CUT PATTERN	
BACK FRAME NO.	
BASE FRAME NO.	
WOOD PATTERN

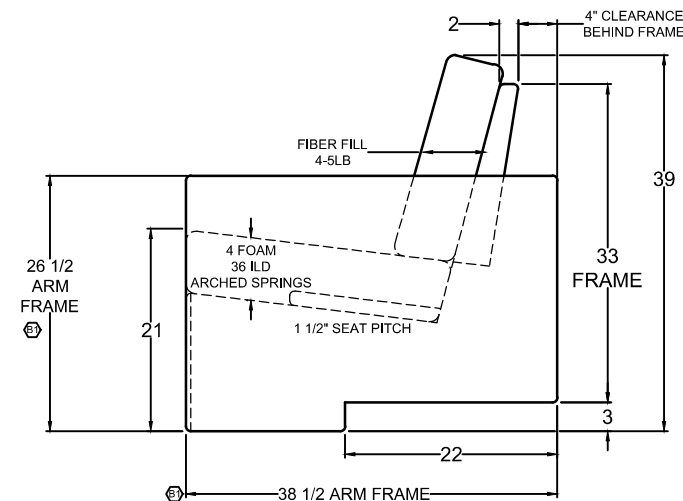
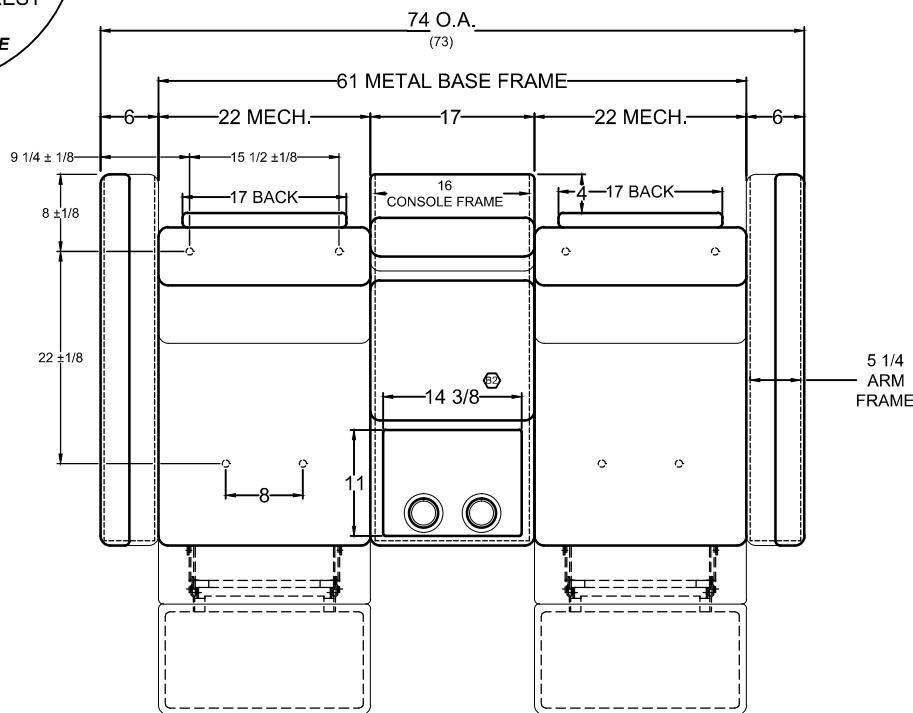
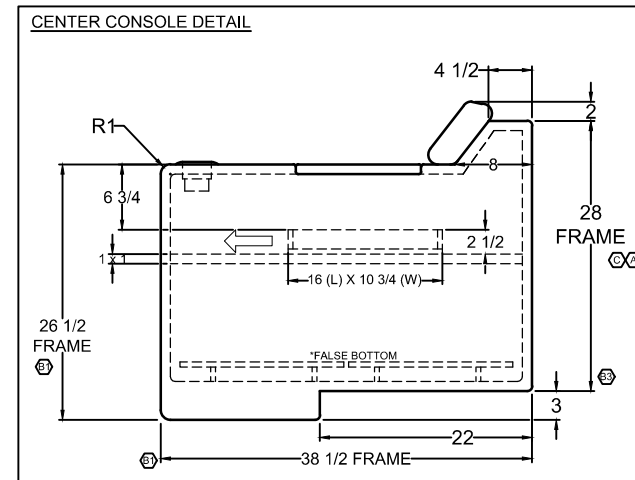
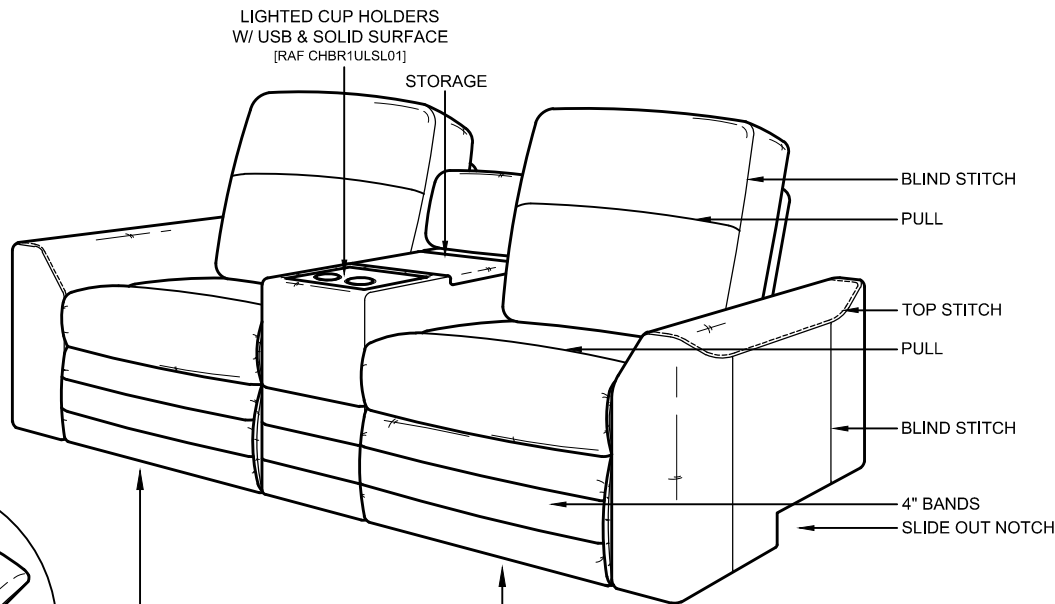
JA	C	CHANGE CENTER CONSOLE BACK FRAME HEIGHT TO 28"; WAS 33". (REF. ECO #003-20205)	01.08.25
JA	B	PER RL, [1] CHANGE ARM & CONSOLE FRAME HEIGHT & DEPTH DIMS TO 26-1/2" x 38-1/2"; WAS 23-1/2" x 37-1/2". [2] CHANGE SOLID SURFACE WIDTH TO 14-3/8"; WAS 13-3/8". [3] REVISE CONSOLE BACK FRAME HEIGHT MEASUREMENT TAKEN FROM TOP OF S/O.	11.12.24
JA	A	PER RL, CHANGE CONSOLE FRAME HEIGHT TO 33"; WAS 31".	10.30.24
